<b>Title-Sujet</b> Logan Creek Bridge Construction – Pacific Rim National Park		
<b>Solicitation No. - No. de l'invitation</b> 5P420-17-5450/A	<b>Date:</b> January 22, 2018	
<b>GETS Reference No. – No de reference de SEAG</b> PW-18-00810188	<b>Amendment No. - N° de la modif.</b> PR00005	
<b>Solicitation Closes:</b>		
<b>at – á</b> 02:00 PM	<b>on – le</b> January 30, 2018	<b>Time Zone - Fuseau horaire</b> MST - HNR
<b>F.O.B. - F.A.B.</b>		
<b>Plant-Usine:</b> <input type="checkbox"/>	<b>Destination:</b> <input checked="" type="checkbox"/>	<b>Other-Autre:</b> <input type="checkbox"/>
<b>Address Inquiries to: - Adresser toute demande de renseignements à :</b> Rebecca Chen		
<b>Telephone No. - No de téléphone</b> (403) 292-8509	<b>Fax No. – No de FAX:</b> 1-866-246-6893	
<b>Destination of Goods, Services, and Construction:</b> <b>Destinations des biens, services et construction:</b> See Herein – Voir ici

## Amendment 02

This amendment is being raised to amend the drawings, specification document, and to distribute questions and answers submitted via email.

### 12" x 1.5" EXTRUDED ALUMINUM DECKING - OPEN

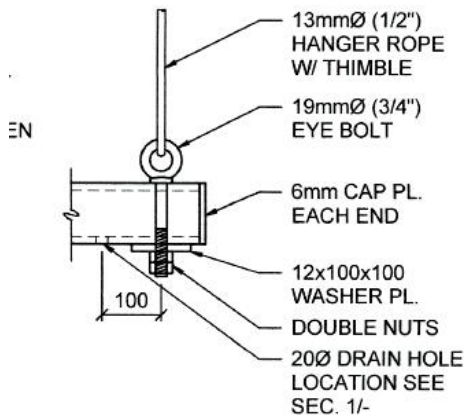
**Q23** Will the attached proposed deck be acceptable?

- A23** Any aluminum decks satisfying the specified requirements, i.e., width, depth, heavy duty, weight, punched, upset pattern for enhanced slip resistance as shown on the addendum sketch AD-S02 and requirements in specification section 05 14 00 are acceptable.

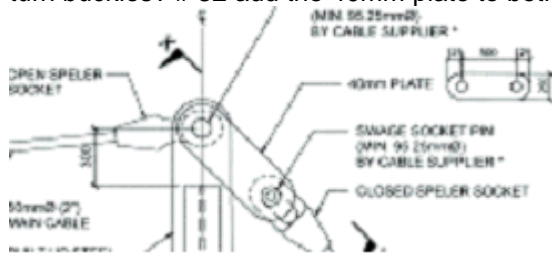
- Q39** Was consideration given to lowering the footing, “so that it sits on the bottom of the excavation,” and raising the up stand wall in order to illuminate the amount of the CDF?

- A39** The tender is based on the footing elevation as shown on the drawings, i.e., top of the footing to be no greater than 200mm below exterior grade.
